Technical product information

Topic	Convertible hood header latch fault
Market area	Bentley: worldwide (2WBE),Hongkong-Macau (5HK)
Brand	Bentley
Transaction No.	2047335/1
Level	EH
Status	Approval
Release date

Continental GT Convertible

Figure 1

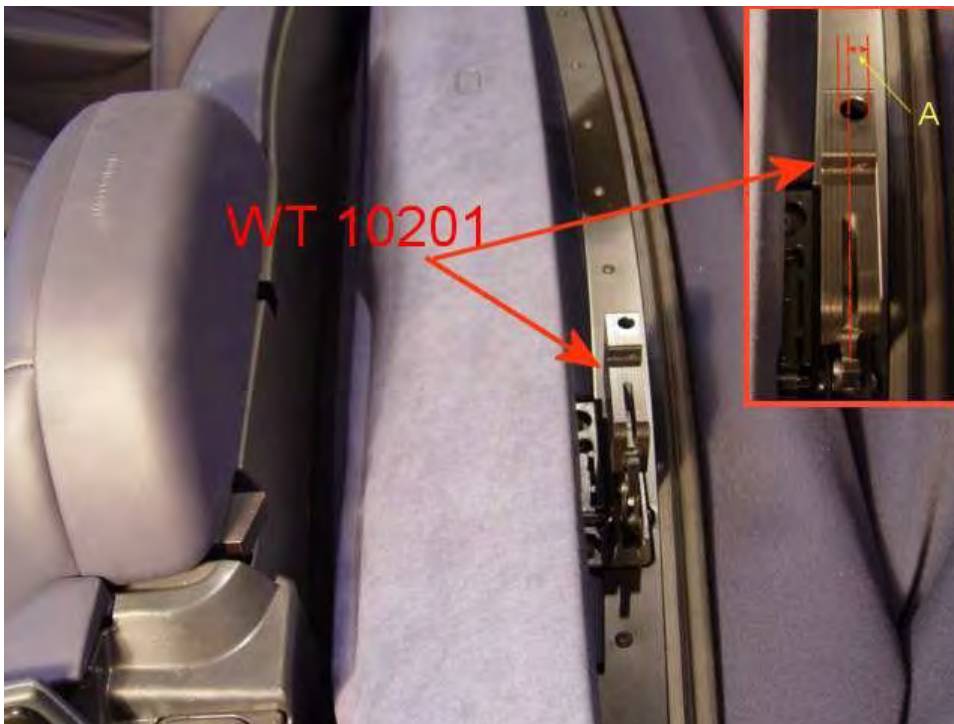
1. Use the power operated roof open and close buttons to partially open the roof so as to position the tonneau cover open and the latch mechanism fully closed (see Figure 1). Note: This must not be done manually

Figure 2

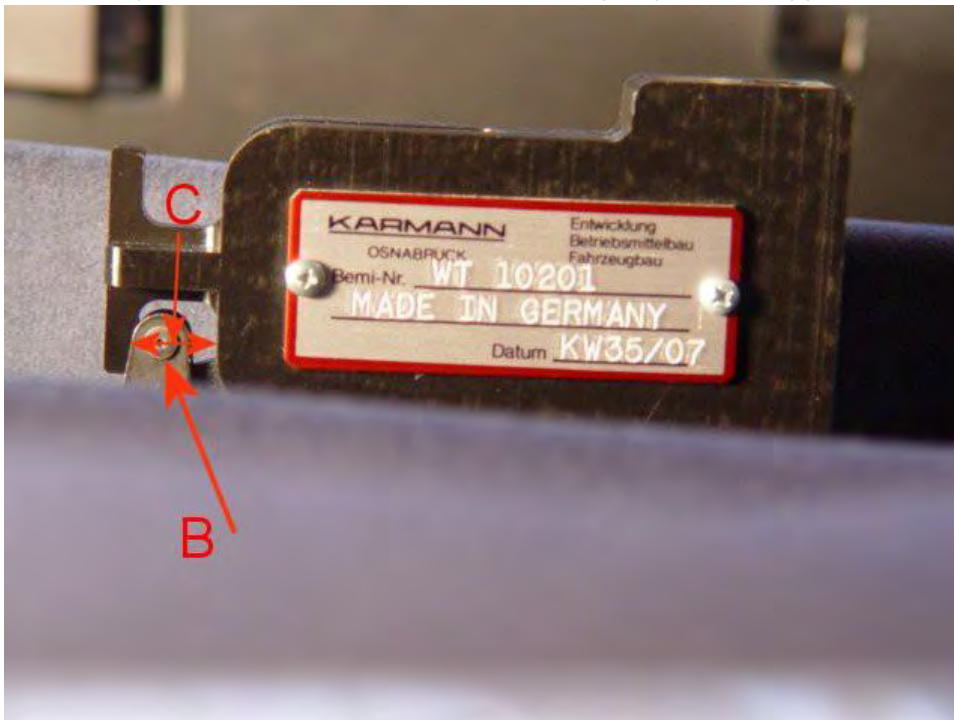
2. Position setting tool WT10201 onto the header latch so that the guide pin hole offset (A) is towards the luggage compartment (see Figure 2)

Figure 3

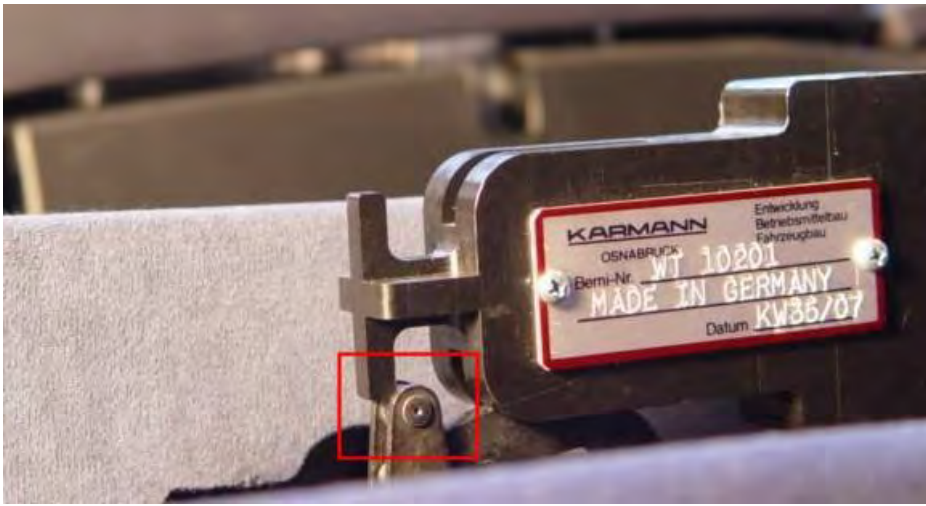
3. With the setting tool positioned on the guide pin the rolllink (B) should fit into area (C) of the gauge (see Figure 3)

Figure 6

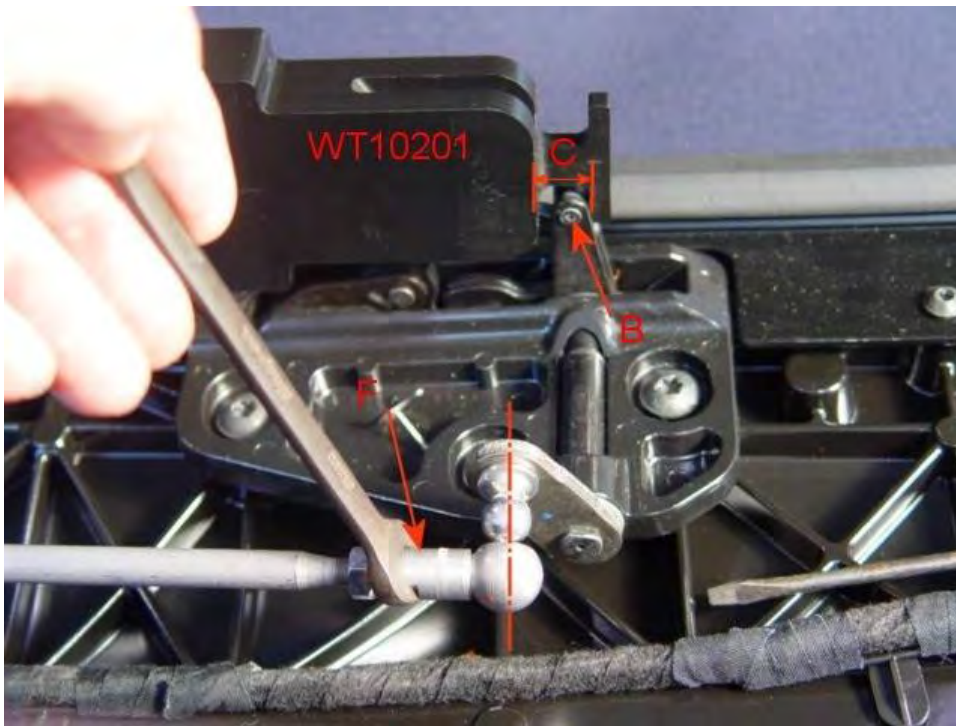
8. Remove the retaining clip from the ball joint and separate the ball joint (see Figure 6)
